CONSIDERATION OF AND/OR ANY APPROPRIATE ACTION ON PANORAMA STREET PRELIMINARY PLAT, SITUATED IN THE PHILLIP ANDERSON SURVEY, ABSTRACT NO. 10 CITY OF PARKER, COLLIN COUNTY, TEXAS. [MACHADO]

Re: Panorama Street
 Preliminary Plat and Engineering Plan Review

As you requested, we have reviewed the Preliminary Plat & Engineering Plans for the Panorama Street Addition prepared by LJA Engineering, Inc. These documents include a new street and is therefore considered a major subdivision under section 155.025 of subdivision ordinance.

CULVERT 1 & CULVERT 2

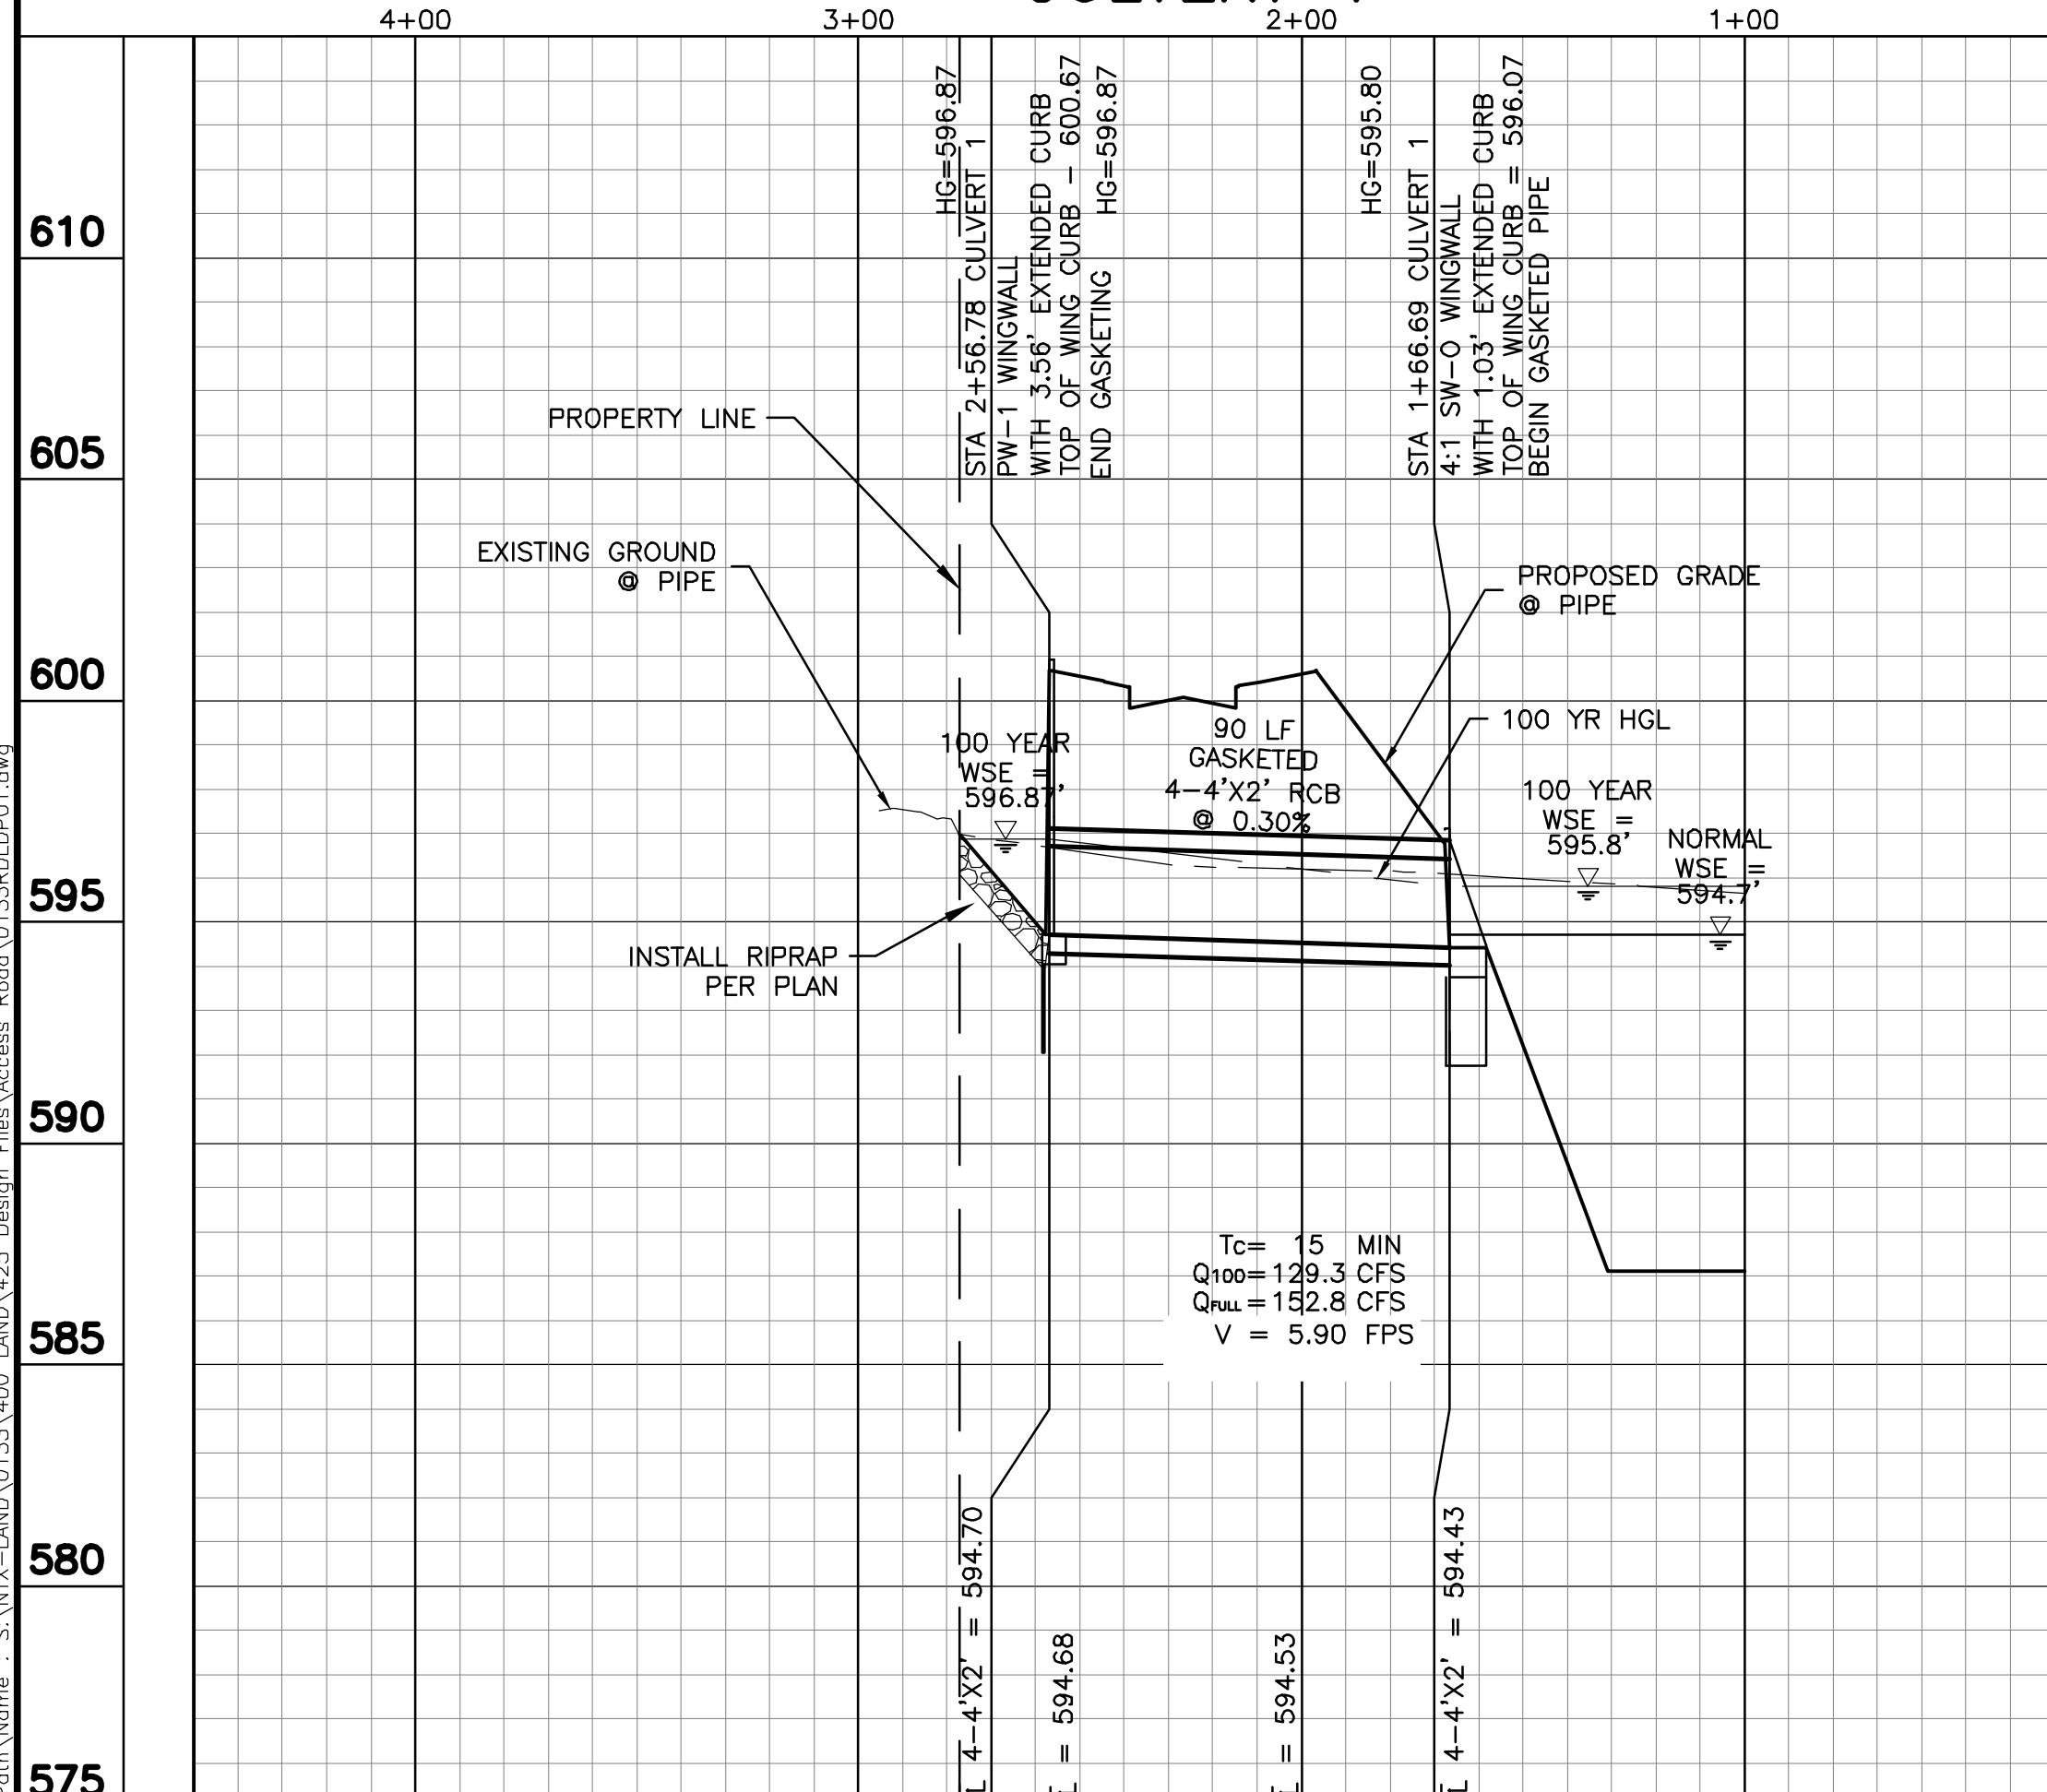
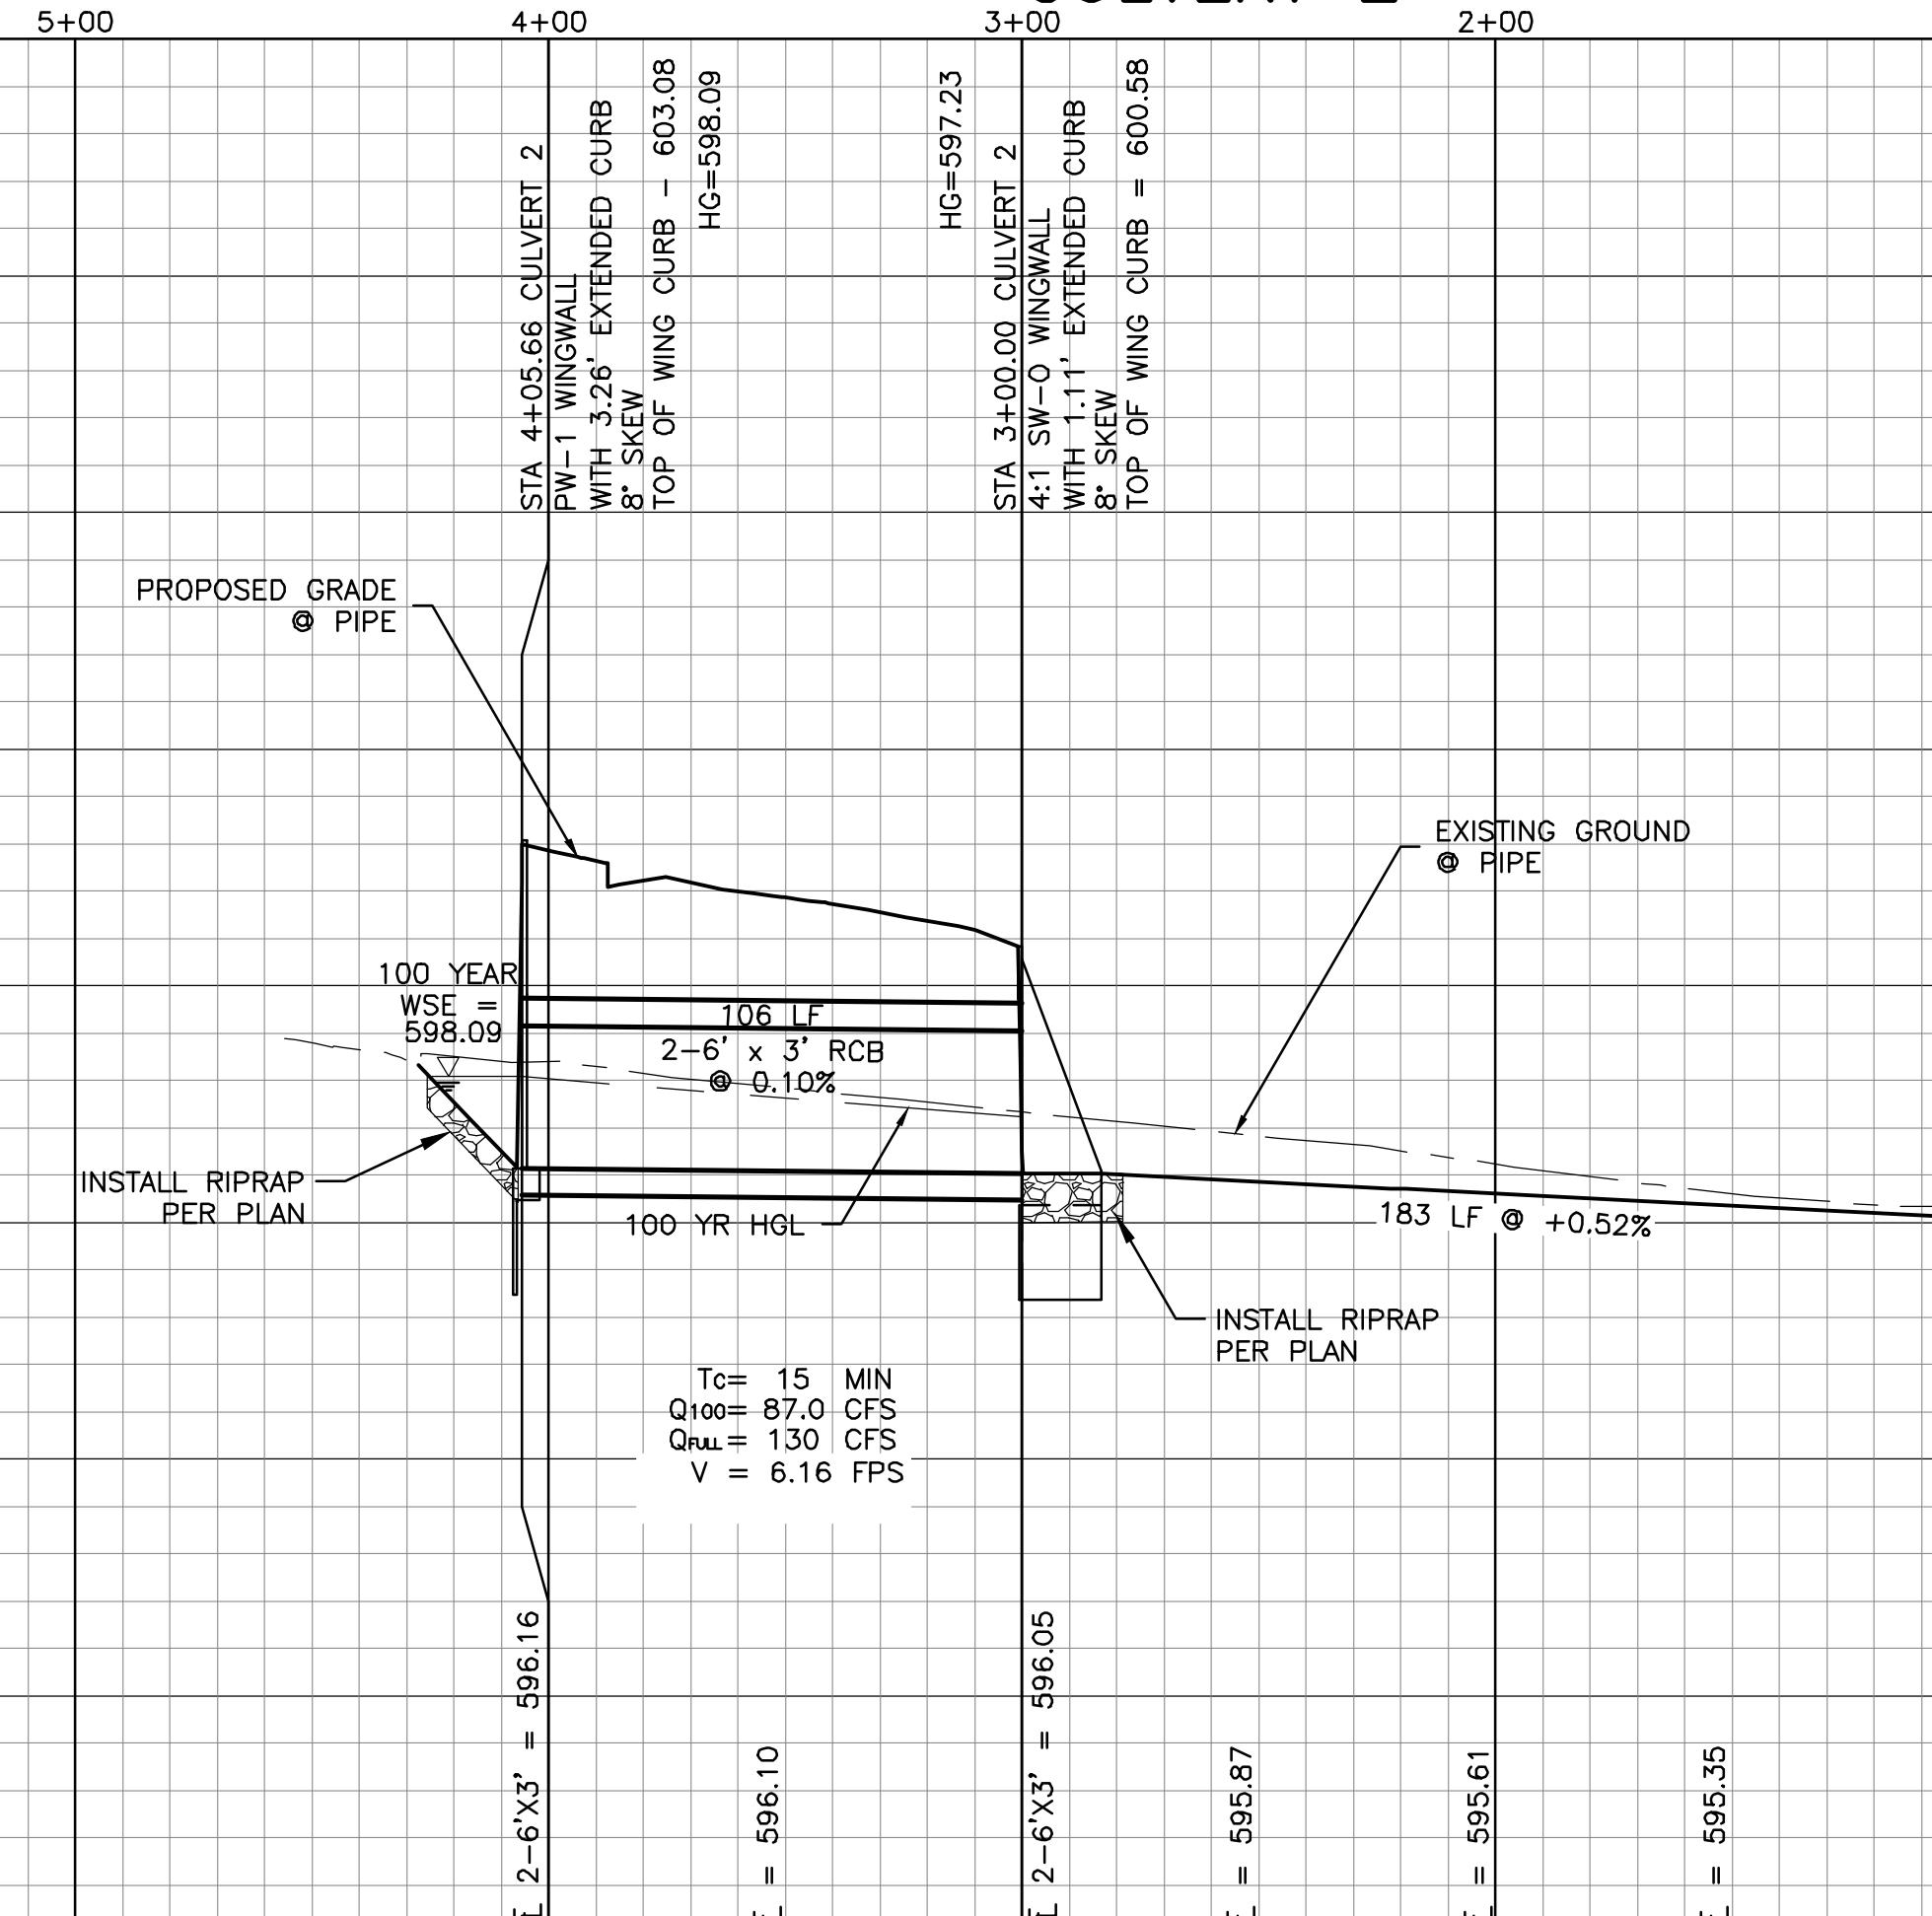
41. Sheet 19 Eliminate bends in the storm sewer system and utilize radius pipe. Eliminate 90 degree turns in the storm sewer system.
42. Sheet 19 Provide a handrail detail for the called pedestrian rail.

43. Sheet 19 Provide depth of the rock rip rap. Include geotextile fabric as the foundation for the rip rap. Call out type of fabric proposed. Detail calls out for grouted rip rap and that will be required. Provide method for contractor to complete the grouted rip rap. Last few projects the grouting was of poor workmanship and concrete rip rap was utilized to solve the poor workmanship.

44. Sheet 19 It is unclear how the outfall of Culvert 2 conveys storm water to the existing channel as the proposed and existing contours are not tied together.

45. Sheet 19 there appears to be footers at the outfall, but no dimensions or callouts are provided.
46. Sheet 19 Culvert 2 cross section shows a curb leave out that is not called out in the plan view.
